Barry Williams
1701 Cedar Crest Dr, Abilene , Texas

Inspection date
July 23, 2021

Level of inspection
Level I and parts of Level II

Prepared by
Brody Earles CSIA#10109
Shanes Chimney Care LP

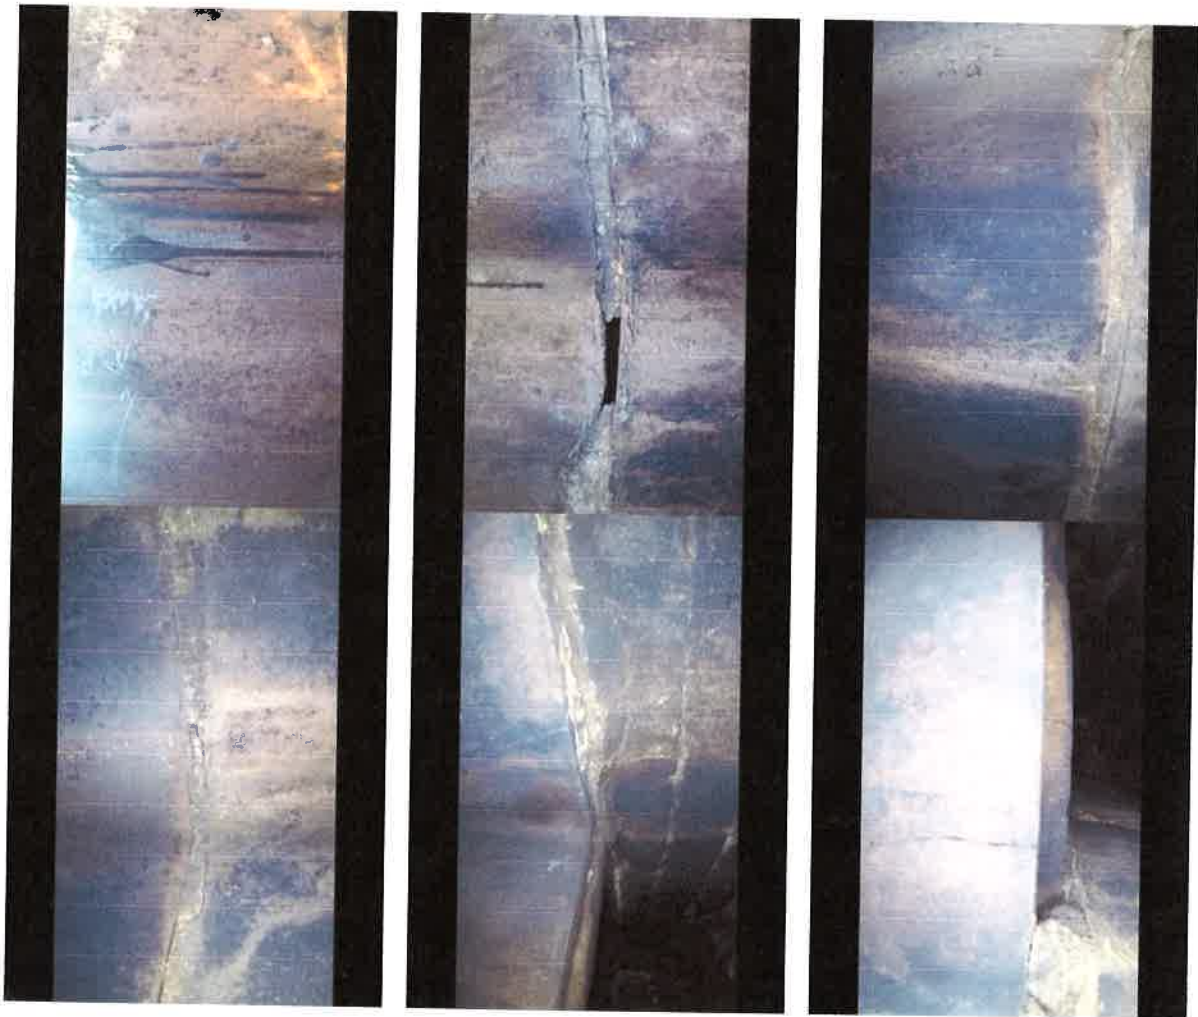
- **Brick / Stone / Chimney walls condition:** Meets industry standards
- **Crown / Wash cap:** Needs attention

This chimney has the presence of roofing tar, a combustible material, as a sealant. This is dangerous as the temperature around the flue could possibly ignite the tar and start a roof fire. Some of that tar has melted and begun running down the inside of the flue.
